Information

CAR RADIO CASSETTE PLAYER
22AC868/80

A77-321

During production the following modifications have been introduced:

Fig. 1a

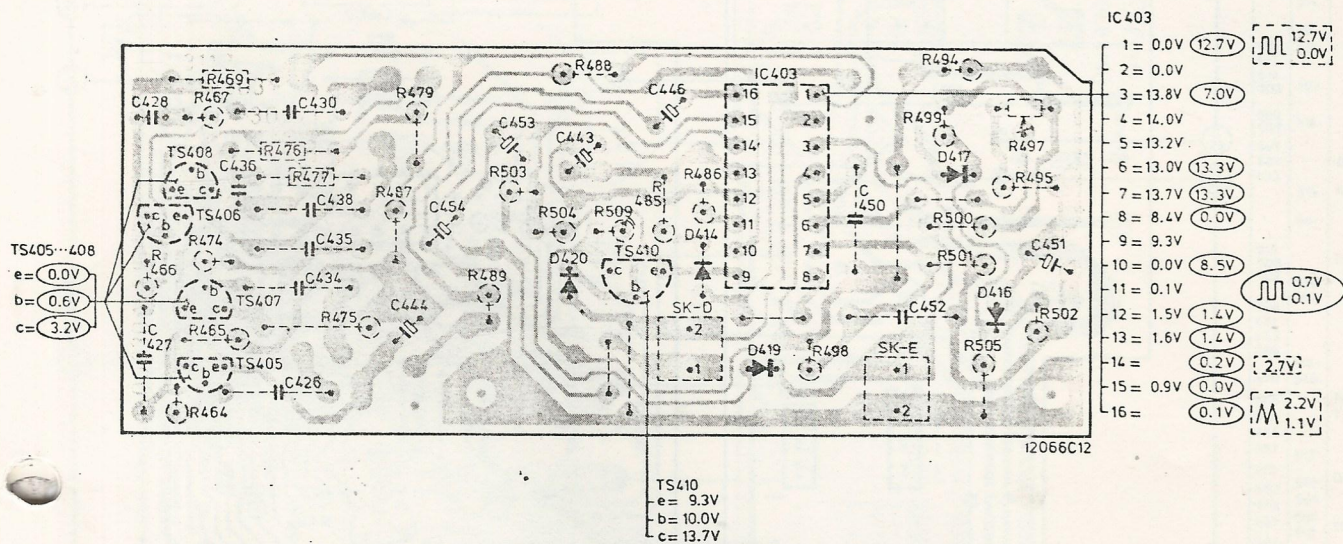
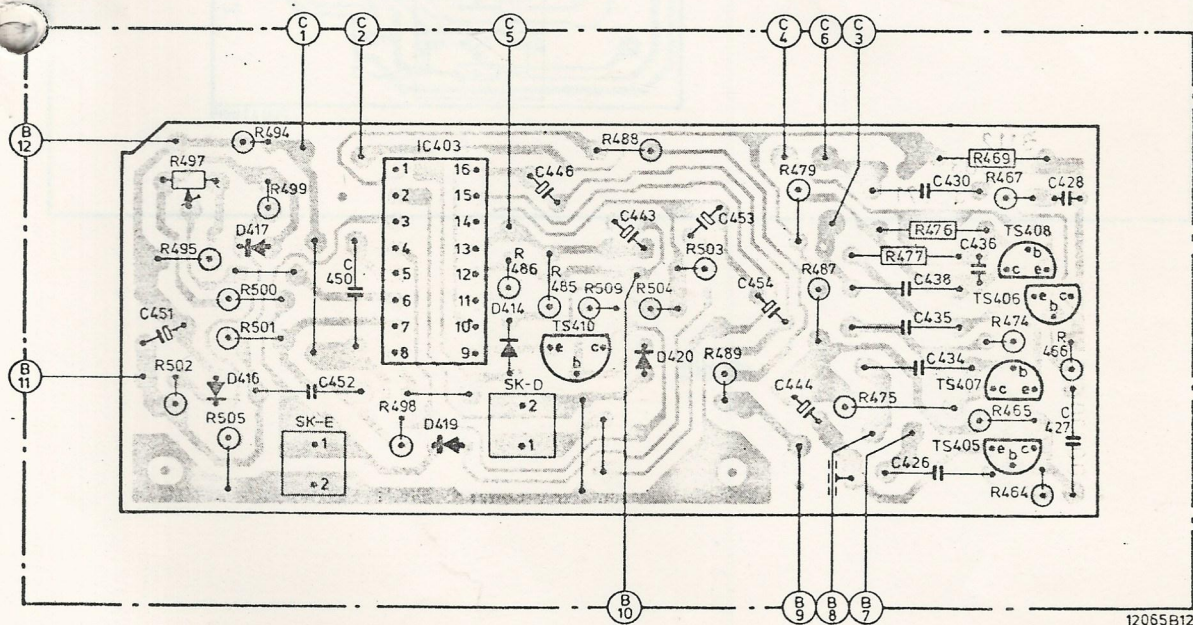
- From week 701 print 5 (REC) has been replaced with a "fall-pipe" version (no electrical modifications). See Fig. 1. The sets are marked with a capital F on the factory plate.
Reason: Simplification of production.

Fig. 2a

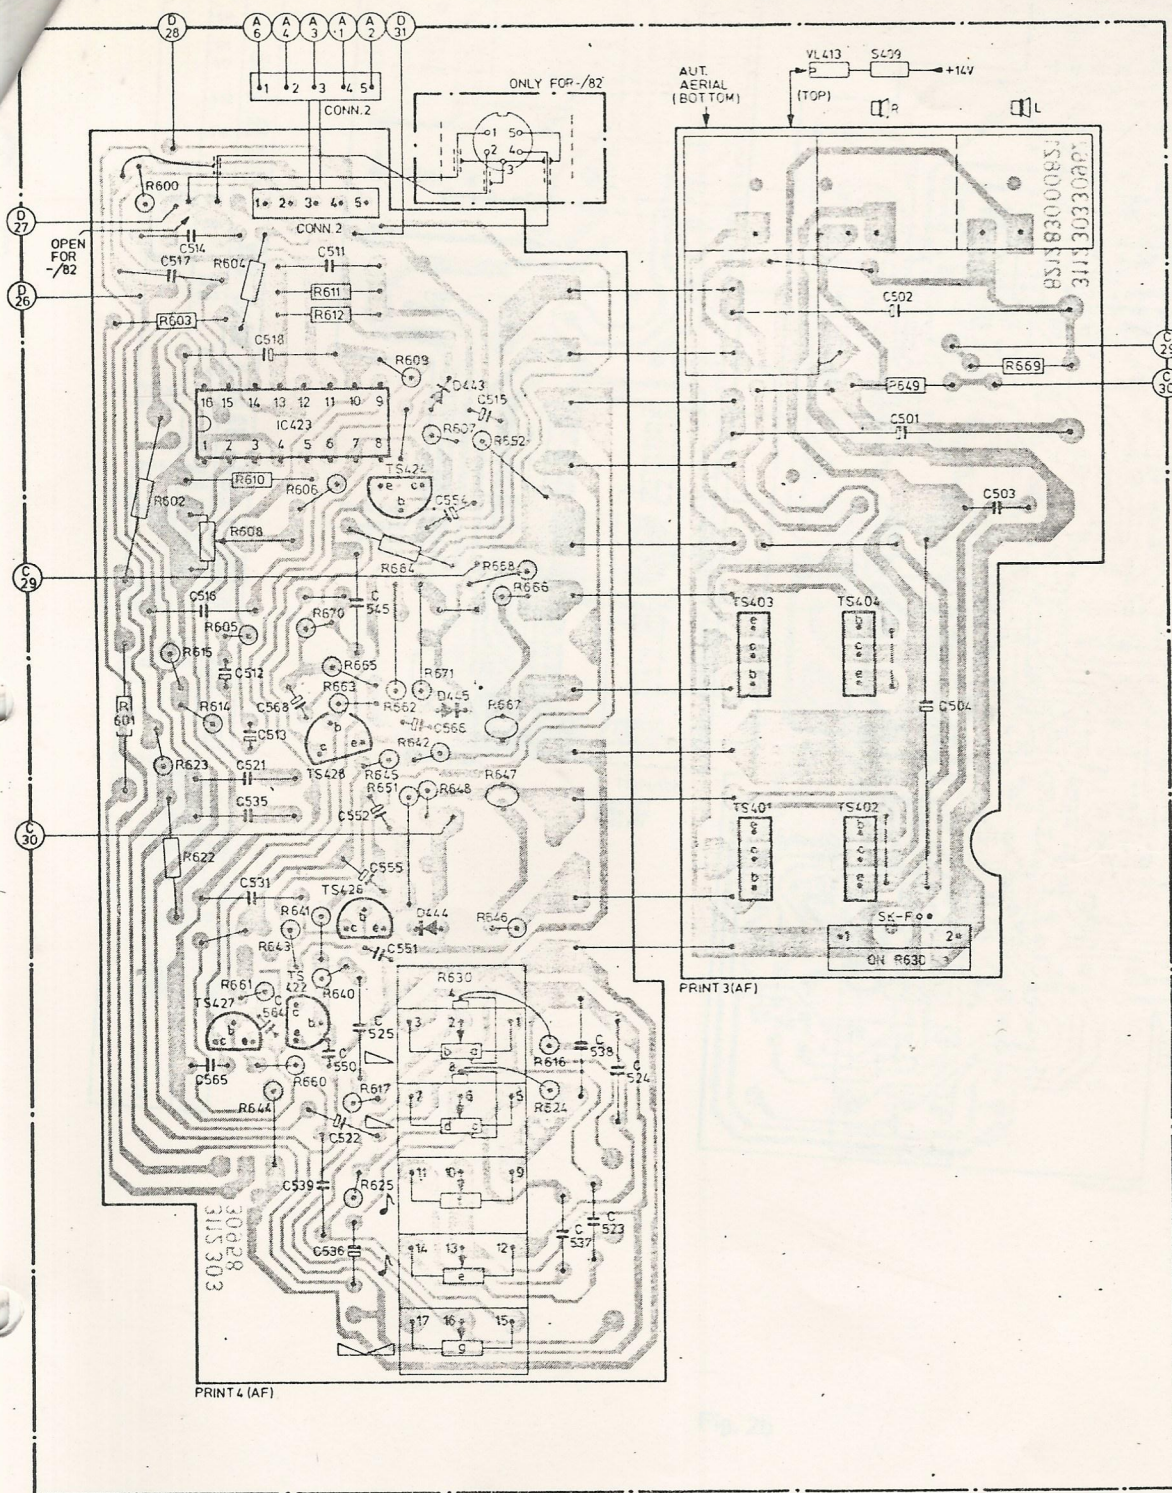
- With code WA01, connector 3 has been omitted. The three connections are now soldered direct to print 4 (AF). Besides the jumper between R644 and connector 3 and R644 itself have been displaced (see Fig. 2).
Reason: Simplification of production.

- As stated in A76-314 the value of C521 and C535 had been modified.
This has been introduced with code WA02.
- The resistors in series with the wiper of R630 are R617 and R625 (see A76-314). By adding these resistors, one had to modify the track of print 4 (AF). At the same time several modifications were made to the track, for instance, near connector 2, C523/524 and R612 (see Fig. 2).
Reason: Simplification of production and a universal print for various sets.
